MONTGOMERY COUNTY HISTORIC PRESERVATION COMMISSION
STAFF REPORT

Address:	23 Primrose St., Chevy Chase	Meeting Date:	10/10/18
Resource:	Contributing Resource Chevy Chase Village Historic District	Report Date:	10/3/18
Applicant:	Elizabeth McGrann	Public Notice:	9/26/18
Review:	HAWP	Tax Credit:	N/A
Case Number:	35/13-18BBB	Staff:	Dan Bruechert

Proposal: Siding replacement, hardscape alteration, window alteration, entrance alteration, and fence alteration.

2
A000 **PROPOSED SITE PLAN**
SCALE: 1/8" = 1'-0"

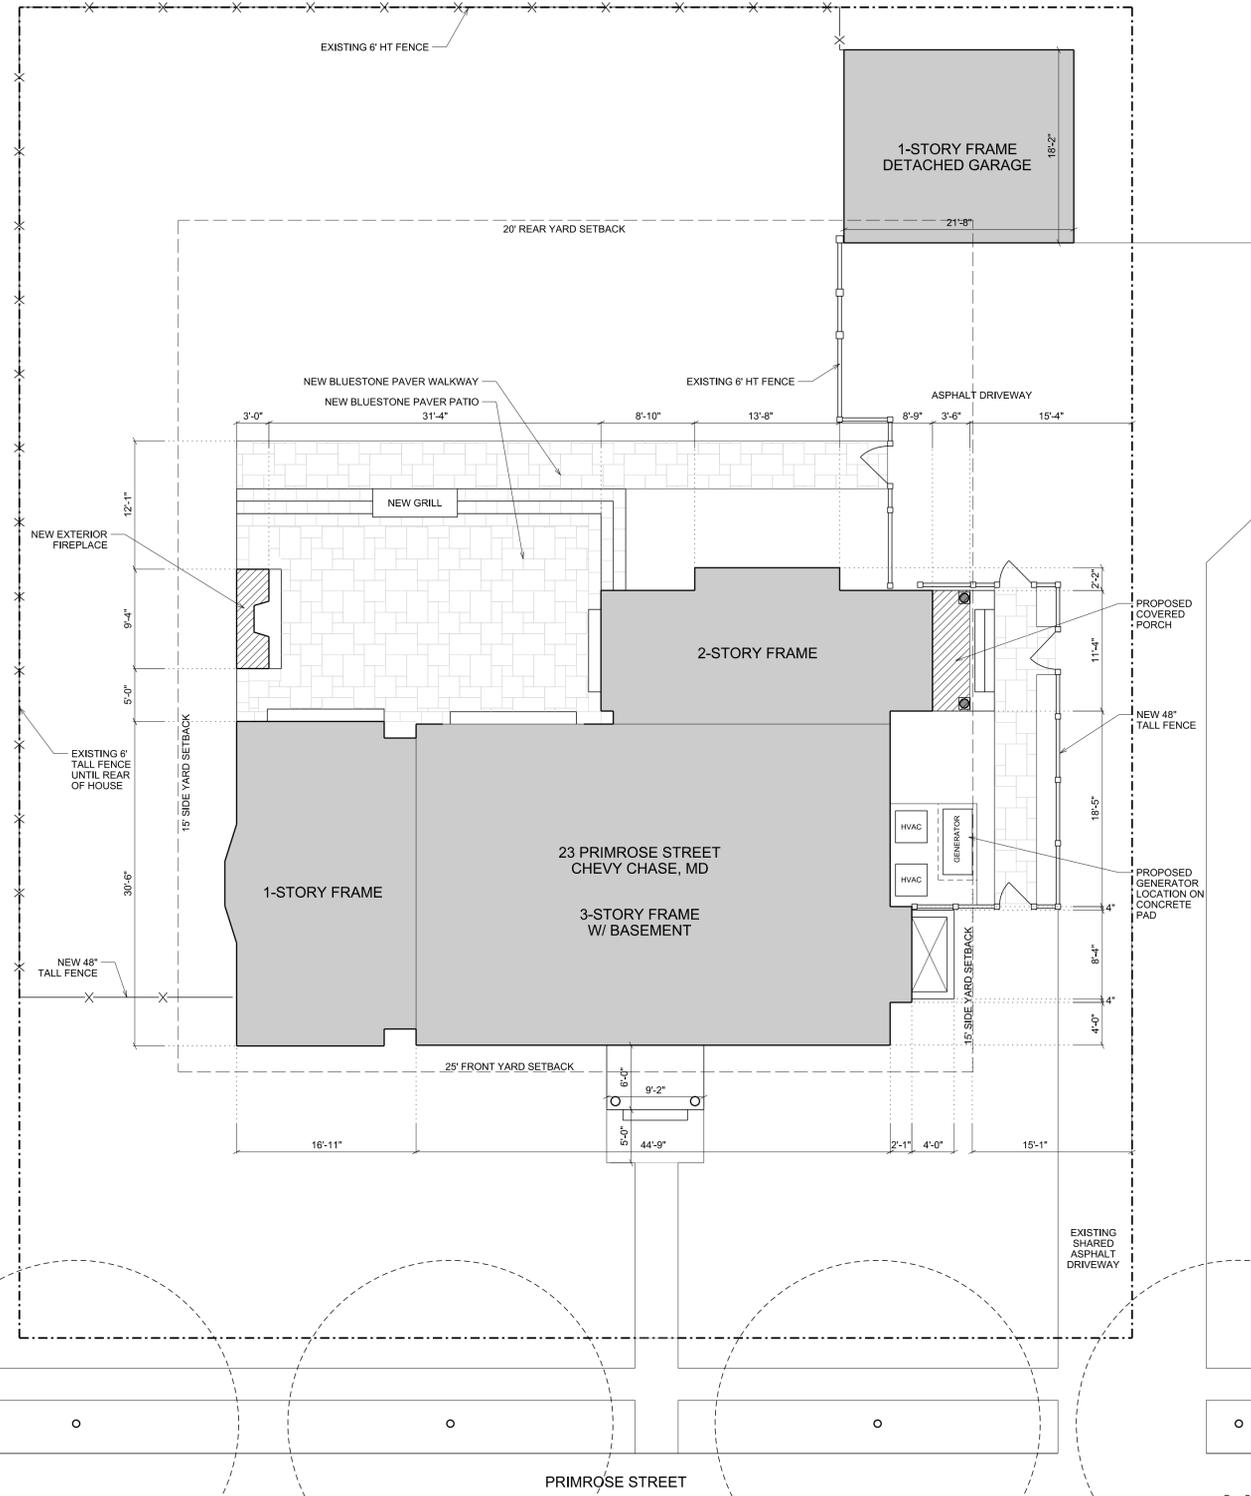
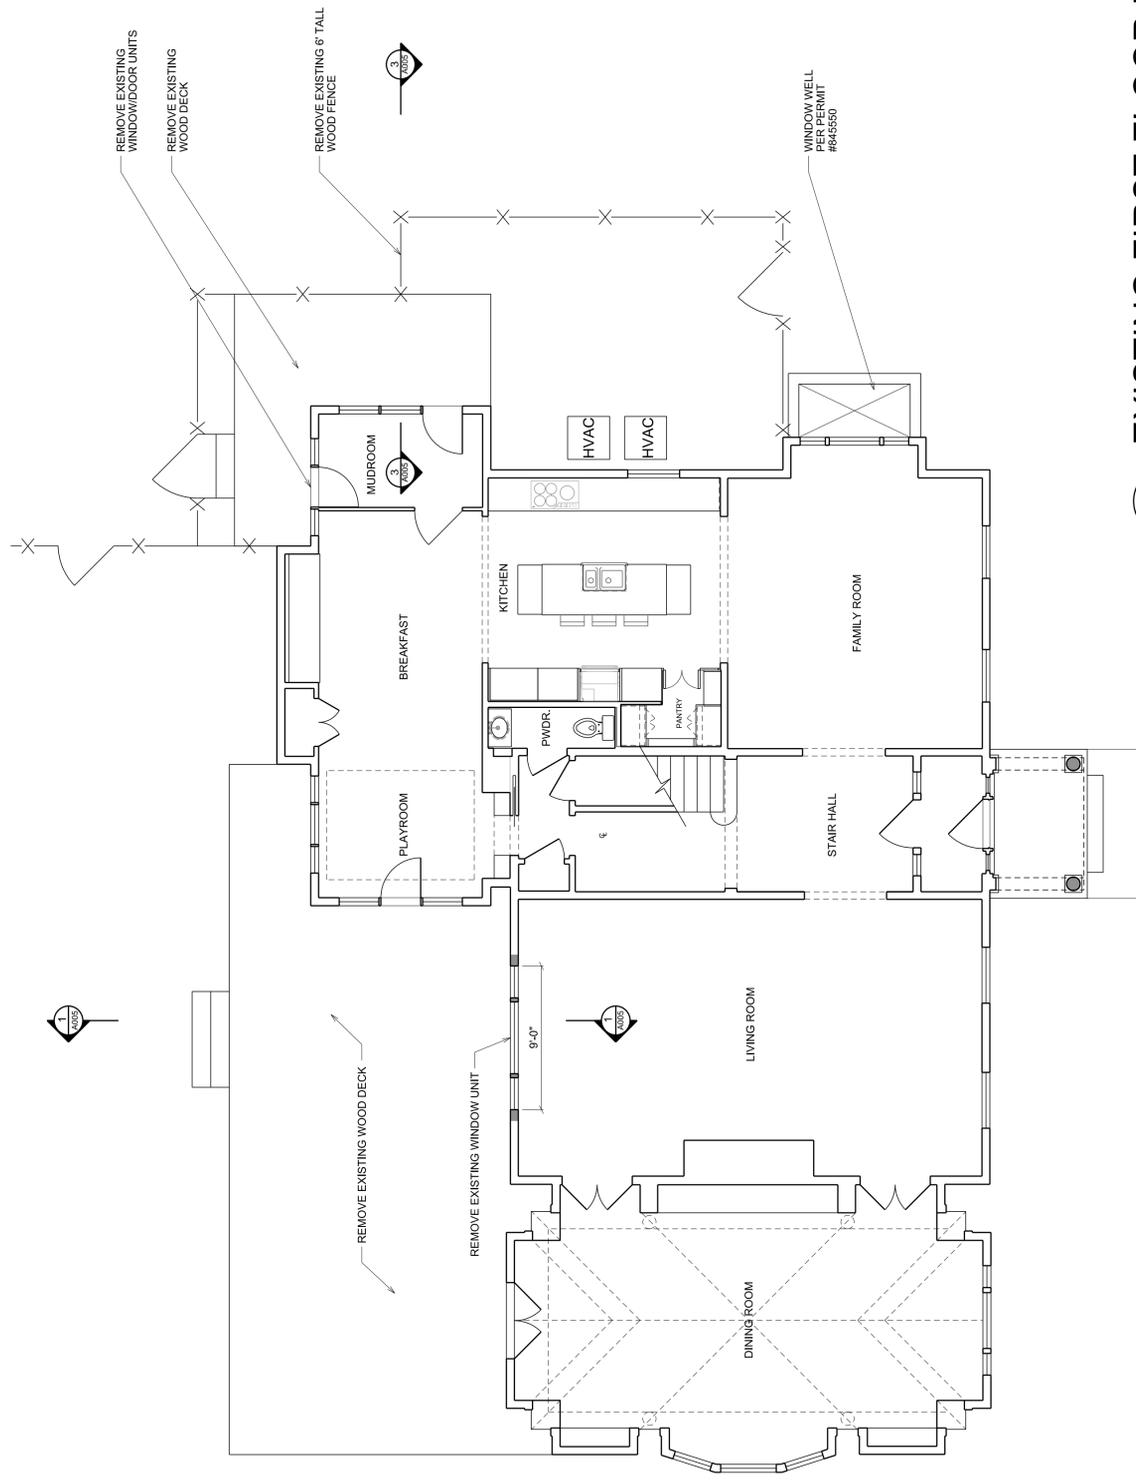
There is a non-historic wood deck off the rear (north) of the house, accessed from the non-historic rear additions. The applicant proposes to remove the deck and construct a rear bluestone patio on grade with a built-in fireplace and grill. The patio will not be visible from the public right-of-way and is subject to lenient scrutiny. Staff supports approval.

The applicant proposes to construct a 22' × 36' (twenty-two feet by thirty-six feet) bluestone patio with a walkway extension. This feature will be constructed on grade, behind the house and will not be at all visible from the public right-of-way. While the *Guidelines* do not specifically call out patios, both porches and decks that are not visible from the public right-of-way are to be given lenient scrutiny, which Staff finds to be an appropriate analogy. As this element will not impact the massing or scale of the house, Staff supports approval of the patio.

2
A002 PROPOSED GABLE SHINGLE DETAIL
SCALE: 3" = 1'-0"

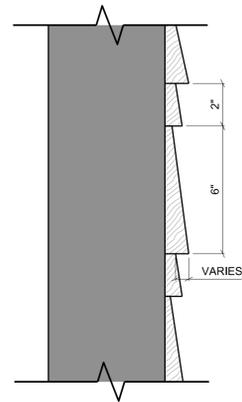
The applicant proposes to remove the existing shingles in the gables and dormers and replace them with wood shingles that match the offset pattern used throughout the house. The subject property utilizes two different shingle patterns. On the walls the shingles are laid in a pared pattern, where the offset of one set of shingles is 2" (two inches) and the next set of shingles is offset 6" (six inches), see Figure 4 below. This pattern gives the effect of a striped pattern in the

siding. The shingles in the gables and dormers on both the historic and non-historic additions have evenly spaced shingles. The applicant proposes to remove the shingles in the dormers and gables of the house and replace them with wood shingles that match the offset pattern found on the rest of the walls.

The *Guidelines* state that siding should be subject to moderate scrutiny if it is visible from the public right-of-way...” In analyzing this proposal, Staff finds that matching the existing wood shingles is an appropriate material for the historic house. Staff further finds that the paired-offset pattern used throughout the house is one of its character defining features and that expanding its use into the gables and dormers is compatible with the existing design of the house and will not detract from its historic character (per 24A-8(b)(2)) nor will it be detrimental to the surrounding district. Staff supports approval of replacing the shingles in the gables and dormers.

2
A005 **PROPOSED REAR DOOR / PATIO SECTION**
SCALE: 1/2" = 1'-0"

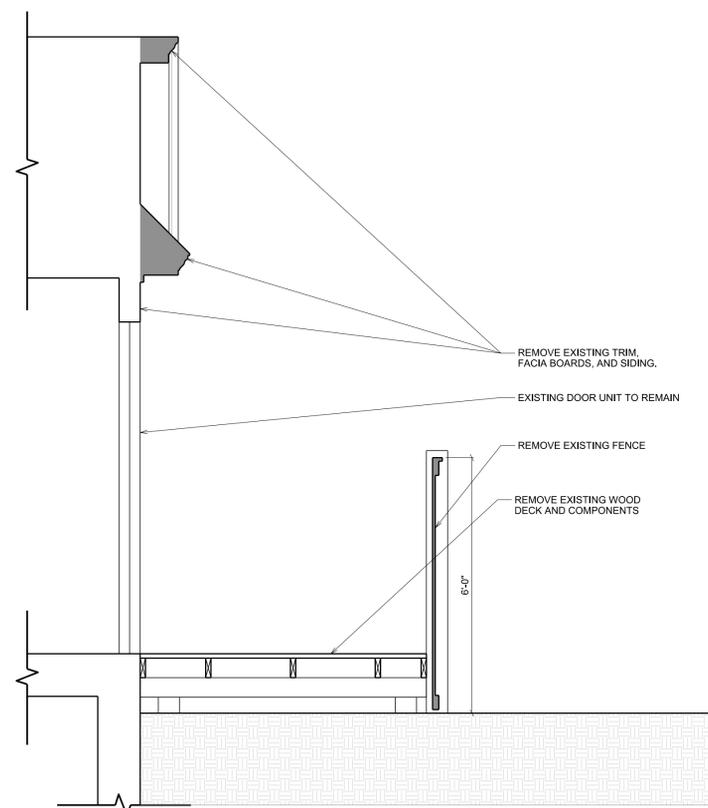
The applicant proposes to remove an existing, non-historic, Chicago window from the rear (north elevation) of the house and convert the opening into a pair of French doors with sidelights. This new feature will provide access to the proposed patio discussed above. As the existing window is non-historic and is not visible from the public-right-of-way, Staff has no concerns with its removal. The proposed doors will be wood with fixed-in-place grilles as shown on the attached building plans. Under the *Guidelines*, doors that are not visible from the public right-of-way should be subject to lenient scrutiny. Staff finds that the proposed doors will not detract from the size, scale, massing of the historic resource, and will be constructed out of an appropriate material and supports approval of this proposal.

4
A005 **PROPOSED SIDE ENTRY**
SCALE: 1/2" = 1'-0"

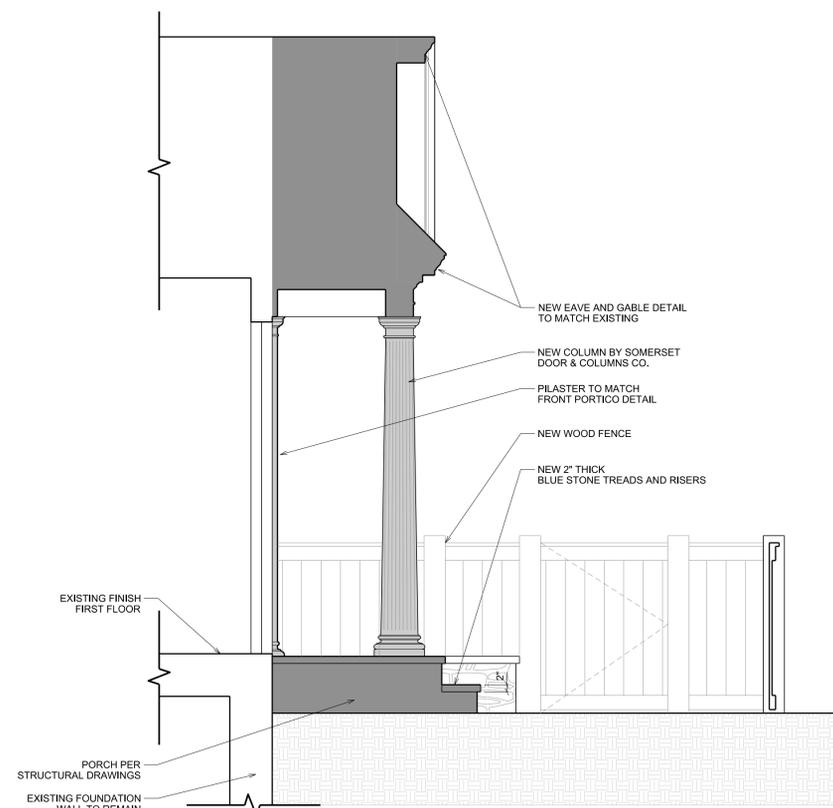
The applicant proposes to construct a new portico over the entry porch on the east elevation. The existing porch entrance is on a non-historic, rear, addition to the house that projects beyond the historic wall plane. The porch has a gable roof with three French doors and engaged square column trim. The applicant proposes to retain the doors in their current location and will

construct a new porch covering that will project 2' (two feet) over the existing entrance. The foundation of this new construction will be bluestone, to match addition's foundation material, supported by two wood columns. The roof of the extended porch will follow the existing gable roof-slope and be covered in slate shingles to match the rest of the house. The new porch roof will project approximately 1' (one foot) beyond the existing front bay on the east elevation.

Staff finds that the proposed porch expansion is in keeping with the *Guidelines* and recommends approval. The materials proposed are a continuation of the materials currently in use and appropriate for the house. Generally, new construction is required to be inset from the historic to minimize its impact on the historic character of the resource. In this instance, the new construction will project slightly beyond the historic construction, however, Staff finds this to be a minor extension that will not impact the historic character of the house for two primary reasons. First, the porch extension is occurring off of a non-historic element to the rear of this elevation that already projects beyond the historic wall plane. Second, the proposed extension consists of a roof and two columns, so while the massing of this feature will be altered, it will retain a large degree of openness when viewed from the public right-of-way that will not detract from the historic design of the house. Staff finds that the proposal is in keeping with the *Guidelines* and will not substantially alter any of the historic features of the building (see 24A-8-(b)(1)).

EXTERIOR FIREPLACE & GRILL DETAILS

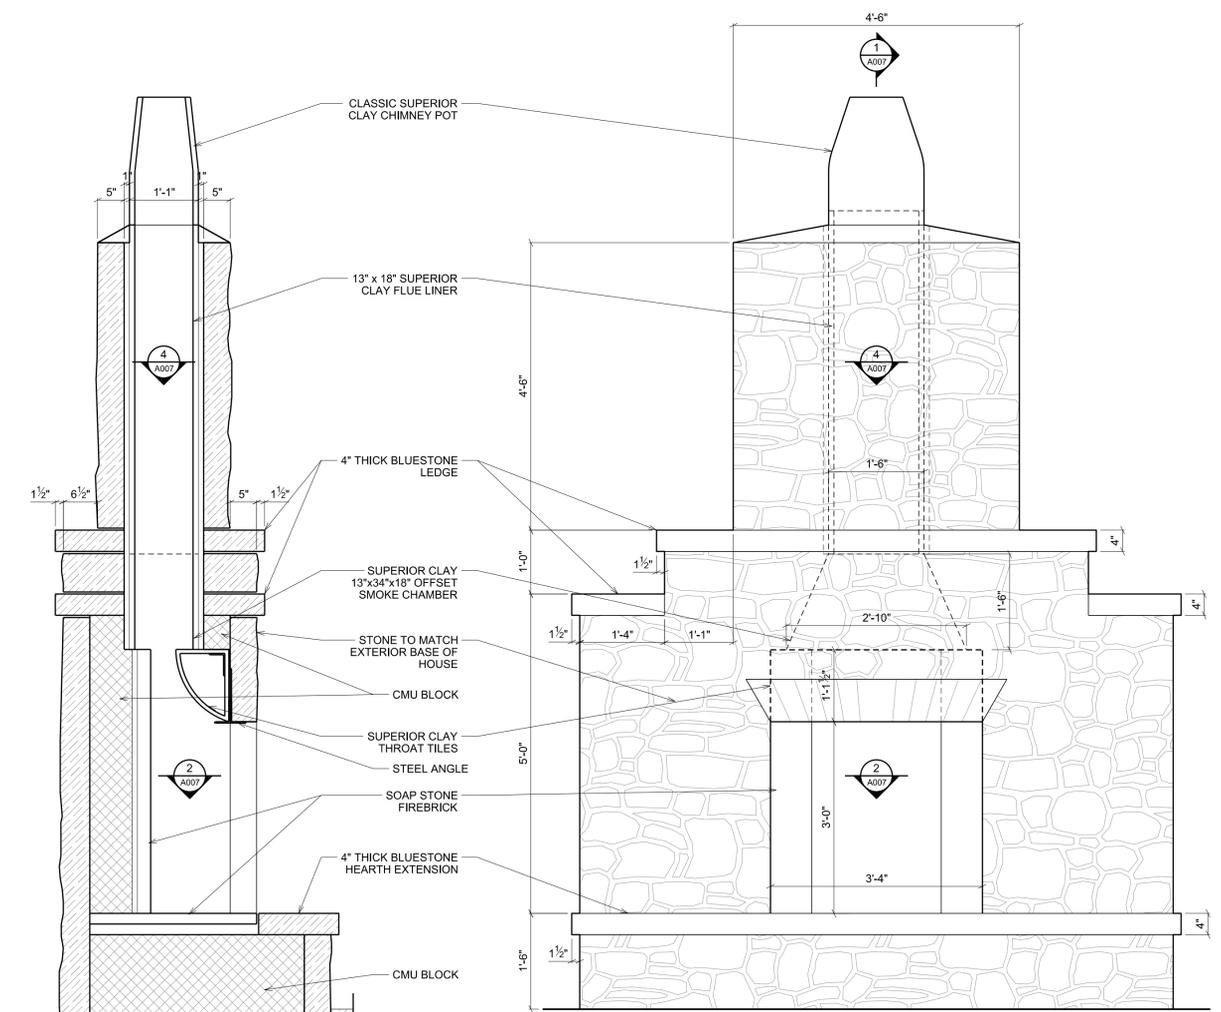
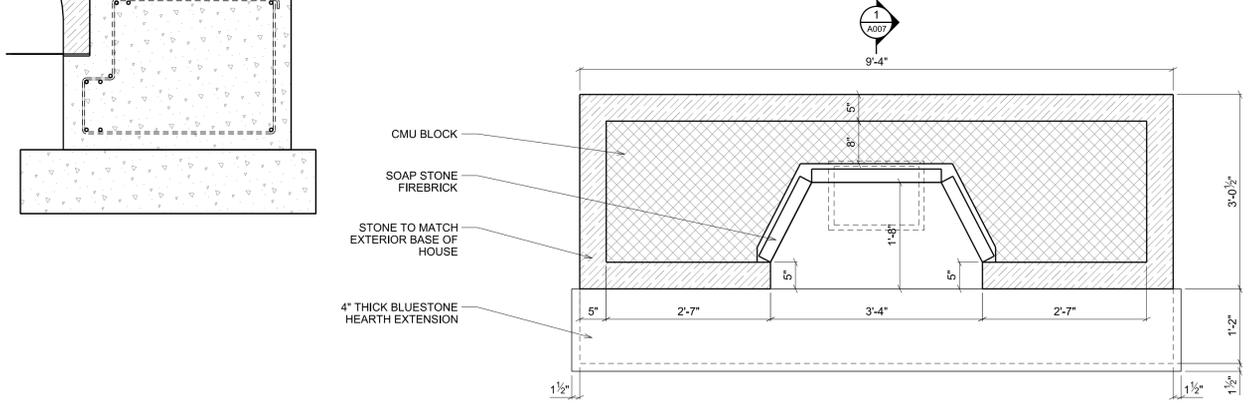
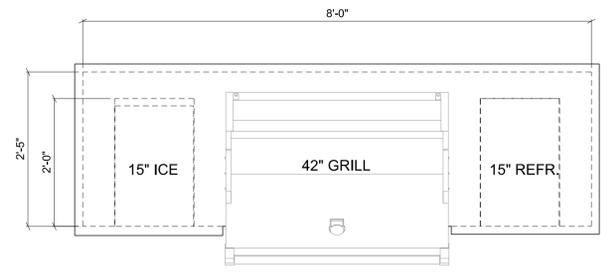
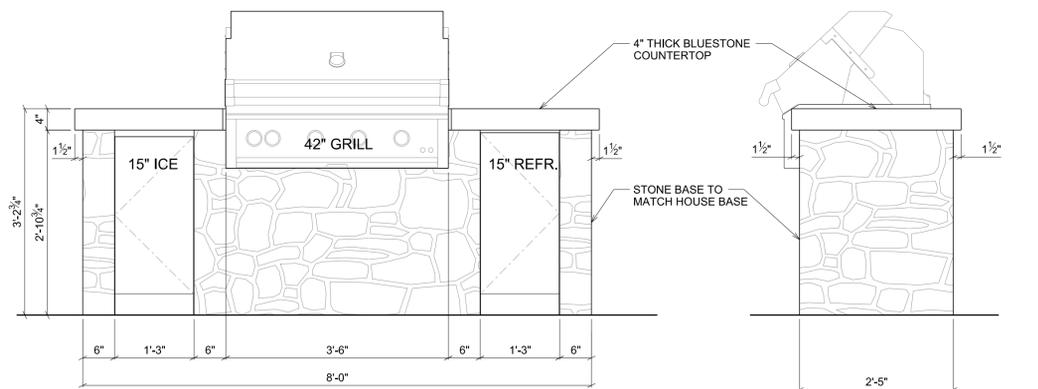
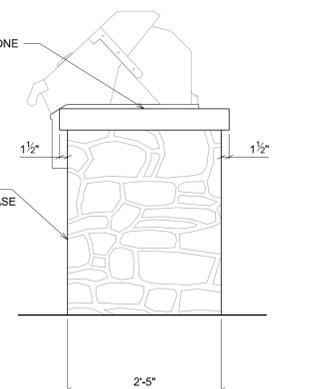
There are two additional features proposed as part of the patio construction, a built-in grill and an outdoor fireplace. Per the *Guidelines*, "Gazebos and other garden structures should be subject to moderate scrutiny if they are visible from the public right-of-way, lenient scrutiny if they are not." The grill will be approximately 8' (eight feet) wide and 4' (four feet) tall. It will have a stone wall around it that matches the foundation of the house. Because of its placement behind the house, the grill will not be at all visible from the public right-of-way and Staff supports approval under a lenient scrutiny review. The applicant also proposes to construct an outdoor fireplace. The exterior of the fireplace will use stone to match the foundation of the house and the construction around the grill. It will be approximately 12' (twelve feet) tall with a 2' (two foot) tall clay pot at the top and will be 9' 4" (nine feet, four inches) wide at its base. This feature will be slightly visible from an oblique angle along the public right-of-way from the west of the subject property, so it should be subject to moderate scrutiny. Under a moderate scrutiny review, Staff finds that the materials selected, matching the historic foundation, are appropriate

for an exterior structure for this house. Staff further finds that the construction of this element at the rear of the house will not detract from the size, scale, or massing of the historic resource, nor will it detract from the house's contribution of the historic character of the surrounding district. Staff supports approval of these elements.
